SKF Technical Bulletin

VKJC 1045/1046/5205/5208 – Mandatory Stub-shaft kit replacement combined with driveshaft kit

VW Multivan V, Transporter V

Pic. 1

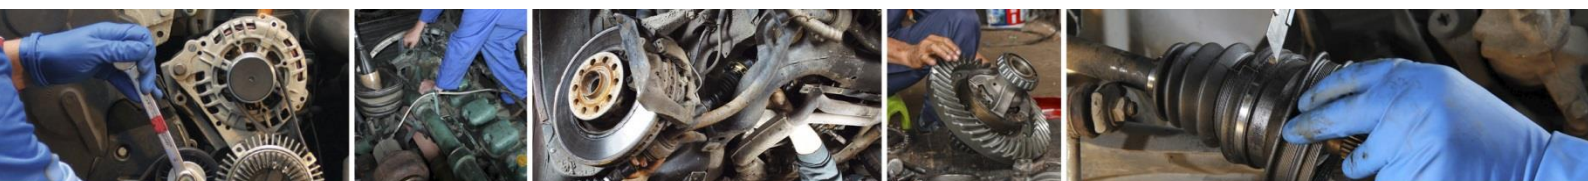
Due to vehicle transmission dysfunctions on the above applications, there are issues with the original gearbox side toothing the driveshaft which leads to premature stub-shaft and driveshaft failure, as shown below on Pic 1 and Pic. 2.

The problem will persist if the driveshaft is replaced without a new stub shaft. Indeed, the toothing of the original stub shaft will present more tolerance than required, so it will prematurely damage the driveshaft toothing.

Therefore, for a complete and professional repair, SKF is offering both components and strongly recommends replacing the driveshaft and the stub-shaft kits at the same time:
